Flood Control Project Maintenance
Levee Inspections

Fall 2016 Levee Maintenance Deficiency Summary Report

Reclamation District No. 2089 Stark

Levee Inspection Report By Mile - Fall 2016

Photo 1 of 2 : SJR2016_RD2089U01RM29.8_1.jpg

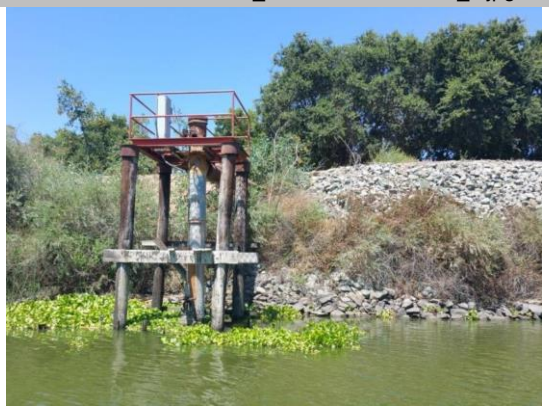
07/25/2016: No significant change observed.
06/25/2015: No significant change observed.
07/02/2014: No significant change observed.
08/13/2013: No significant change observed.
08/07/2012: The site has been visited by boat survey. No significant change observed
08/23/2011: The site shows loose material around the pipe crossing. The operation of the pipe might have caused an impact on the levee.
[2016 Site ID:RD2089U01RM29.8]

Front view of the site. Note the irrigation pipe on the site.

Photo 1 of 1 : SJR2016_RD2089U01RM29.61_2.jpg

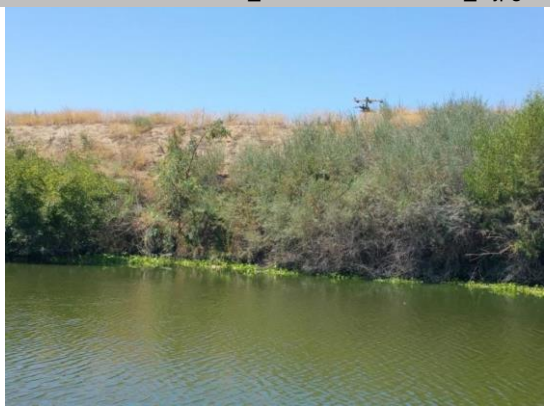
07/25/2016: No significant change observed.
06/25/2015: No significant change observed.
07/02/2014: No significant change observed.
08/13/2013: No significant change observed.
08/07/2012: The site has been visited by boat survey. No significant change observed
08/23/2011: The 5-foot vertical scarp shows no significant change from the last year inspection. No new erosion activities observed. Dense white willow trees on site.
09/07/2010: It was difficult to view the erosion due to the thick Willow thickets and other vegetation at the water line. At the time of the inspection, there were no signs of repair on site. As noted during the last survey, there is a 5-foot vertical scarp along the lower slope that may be subjected to high flow velocities.
08/05/2010: Recommended for repair, per CLRO; "Erosion of this site may be subjective to rapid rates of erosion."
09/28/2009: No major change observed; 5-foot vertical scarp is immediately downstream of where berm has tapered; site is recommended as local maintenance issue, per CLRO CES Evaluation 2008 Report; Site # is the same as RM29.6, LM0.60; previously rated "U".

11/05/2008: No change observed; rodent holes on lower slope; wide levee crown. [2016 Site ID:RD2089U01RM29.61]

Front view of the site. Note the very dense white willow thickets on site.

Photo 1 of 2 : UCIP_FA_2016_21587_36635.jpg

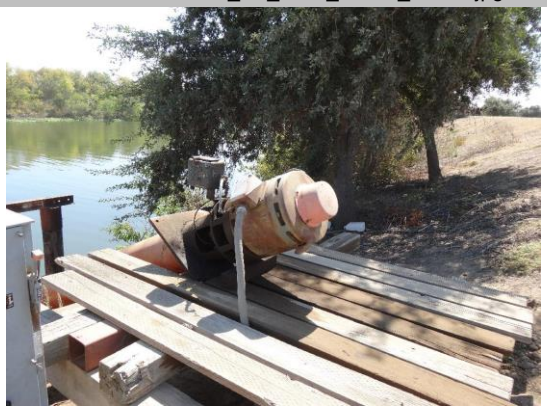
FS_ID:21587
DS_ID:23043
EP_NO: 3385
Repair Type: Non-Urgent
Crossing Status: Found
UCIP Comments: - powerline on landside.- electric control box on waterside.- waterside slope erosion under pump platform.
FIELD_STRUCT_DESC: 16-inch pipe through the levee, 5.5 feet below the crown, slant pump in pump house on the waterward slope. Siphon breaker on the landward slope. (App. No. 3385-Elinore Lawrence). Originally included in O+M (1968)
FS Date: 9/12/2013

WS view: slant pump on wooden platform. Oil leaks from the pump.

Photo 2 of 2 : UCIP_FA_2016_50737_36610.jpg

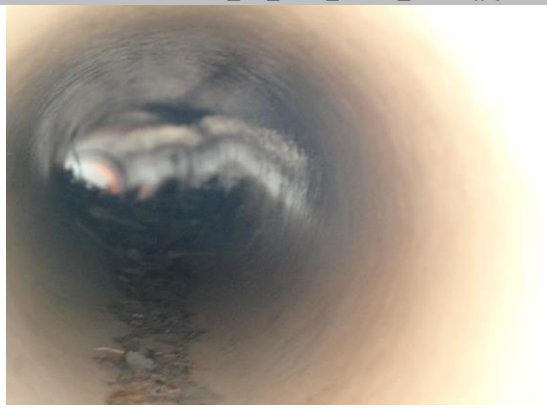
WS view: 6-inch pvc pipe on levee slope. Pipe end open and damaged.

WS view: inside view of pvc pipe. Sediments found inside the pipe.

Photo 2 of 2 : UCIP_FA_2016_21585_36623.jpg

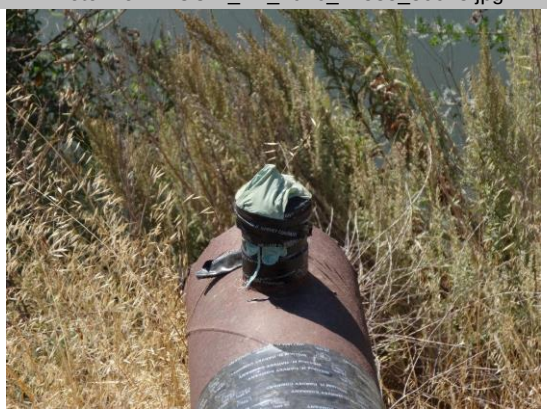
WS view: exposed steel pipe with siphon breaker. Looks siphon breaker needs repair.
